# Product Change Notification

## PCN-017\_2023\_0-OMTB2309301

### Laser marking correction on products ATO series

Beijing, 12<sup>th</sup> April 2023

**D16 models, marking before:** Output cable marking in red area:

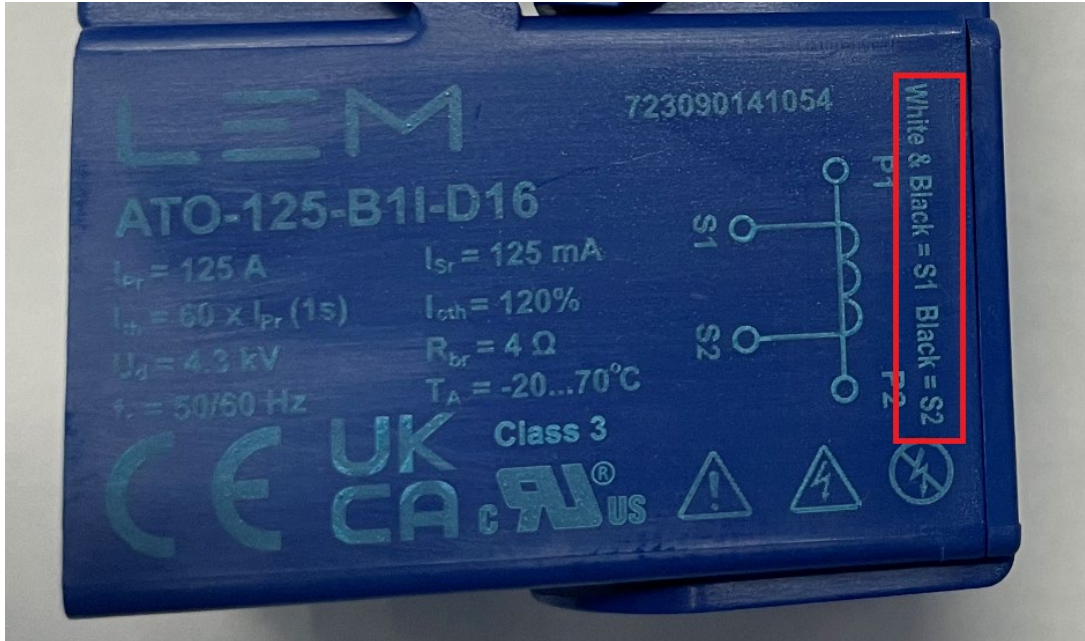
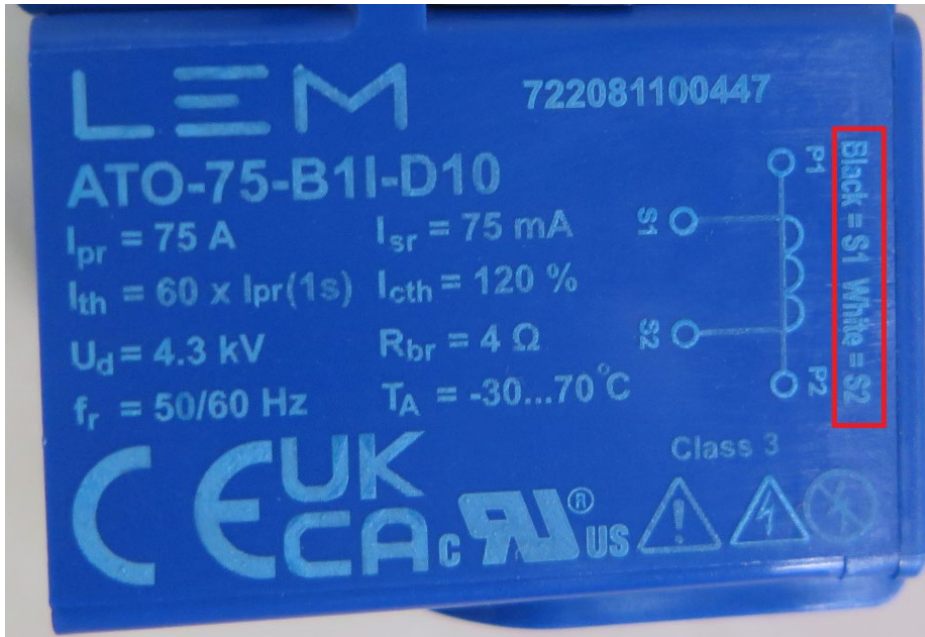
Marking information correction for the output cables S1 & S2 for their function signification.

Currently this is marked on the case of the products that the S1 output cable is black when in fact this is a wire of both colors (black and white).

Currently this is marked on the case of the products that the S2 output cable is white when in fact this is a black wire.

Just change of the wires color signification on the products cases (laser marking) as illustrated here after:

So we correct the current marking on the case of the products to make it matching with the reality and the original information provided in the products data sheets.
